Staff Report Master Responses to Public Comments

Numerous comment letters have been submitted on the Final EIR for the Idaho-Maryland Mine project, which was released to the public on December 16, 2022. Unlike a Draft EIR, a lead agency is not required to provide written responses to public comments on a Final EIR. The County, however, recognizes that many similar concerns continue to be raised in the letters received on the Final EIR, as well as other letters that more generally address concerns related to the proposed project. As a result, this attachment to the staff report has been prepared to make certain master responses in the Final EIR readily available for the decision-makers during the review of the proposed project. Master Responses pertaining to the following environmental topics, which continue to be a central focus of public concerns, are provided below:

Figure 1
Properties Eligible for Domestic Well Monitoring

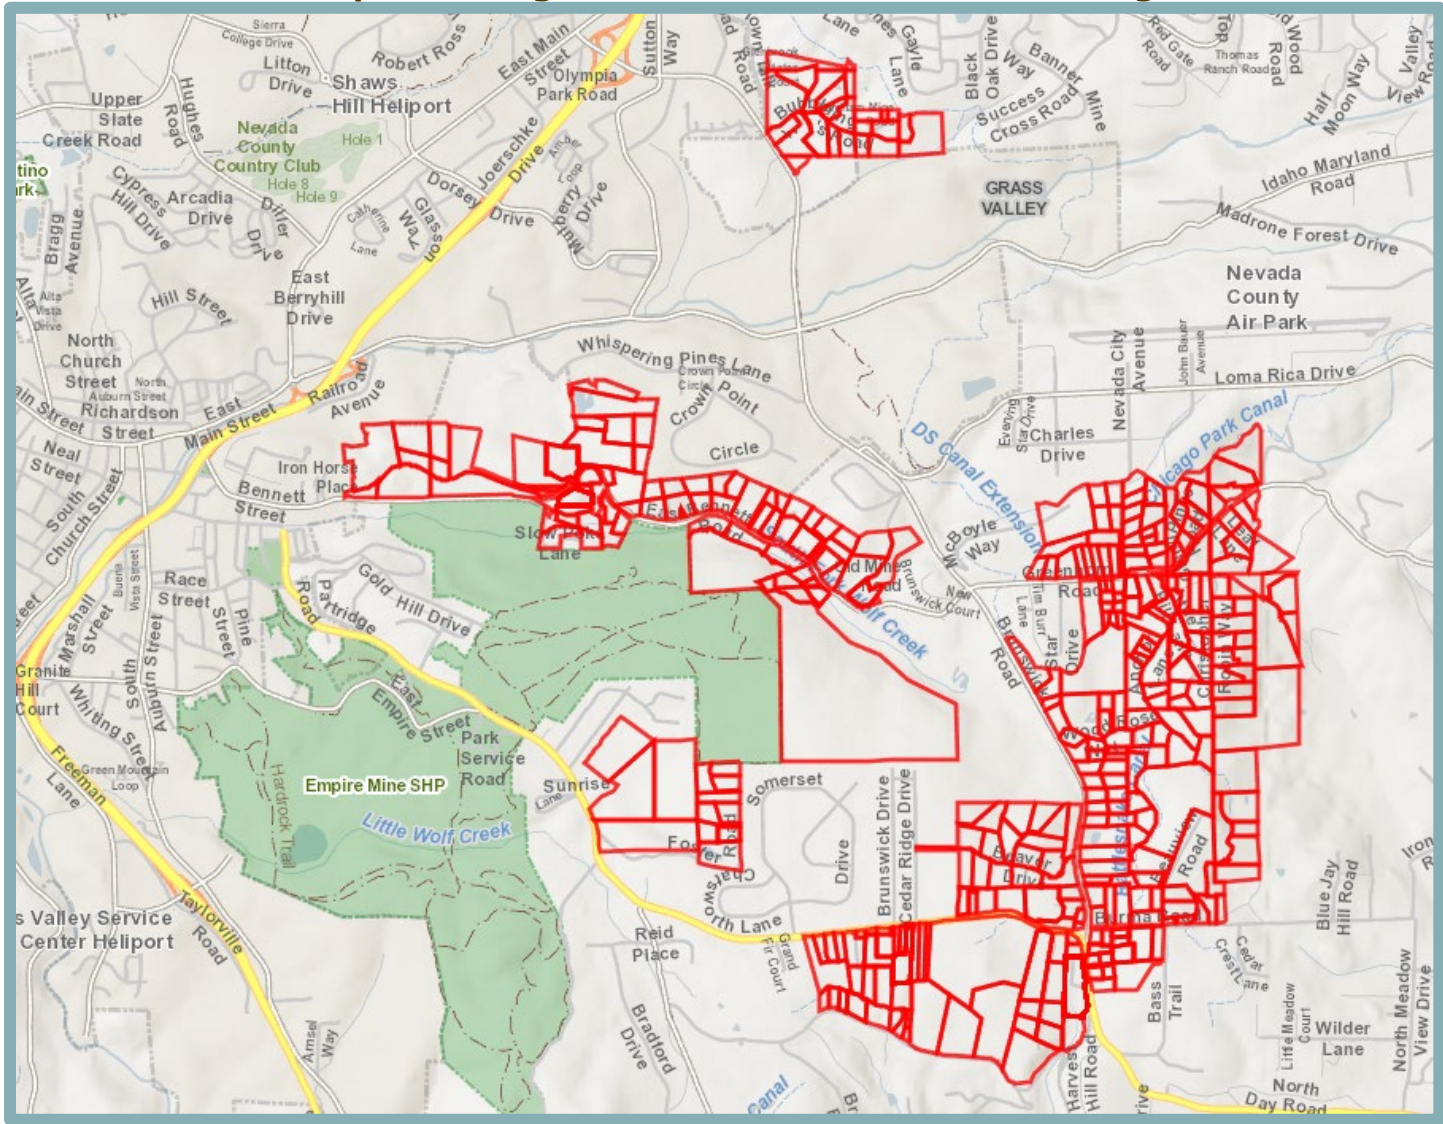
A number of property owners in the area surrounding the Idaho-Maryland Mine Project have expressed concerns about the Project’s impact on their domestic wells, both in terms of drying up their well(s) and adversely affecting well water quality.

To provide property owners additional assurance regarding impacts of mine dewatering, a condition of approval will be imposed on the Project requiring that monitoring of domestic water wells will be conducted upon request for property owners within or nearby the predicted 1-ft drawdown isopleth of the Project. These 378 properties are listed in Table 3 and shown in Figure 18 below. Some of these properties do not have a domestic water well but to ensure that well owners are not excluded all owners will be contacted by the Company. Certain areas, including the City of Grass Valley, Loma Rica Industrial Area, Tim Burr Lane / Star Drive, Cedar Ridge, The Cedars, New Brunswick Court, and Brunswick Pines are known to already be serviced by NID potable water as shown in Figure 19. Property owners in these areas will not be contacted. Please see Appendix E to this Final EIR for the Domestic Well Monitoring Program.

The following measures have been added to the Domestic Well Monitoring Program, and shall be included as a condition of approval for the Project:

- 1) Property owner’s shown in Table 3 will be contacted at least three months prior to commencement of the required 12-month groundwater monitoring period and the company will request permission to inspect and install monitoring equipment at the well.
- 2) Property owners who respond and grant permission for well monitoring will be added to the Domestic Well Monitoring Program.
- 3) The well will be inspected to determine the characteristics of the well, including location, well depth, casing and screen depth, static water level, and well yield. A water quality sample will be taken during the inspection.
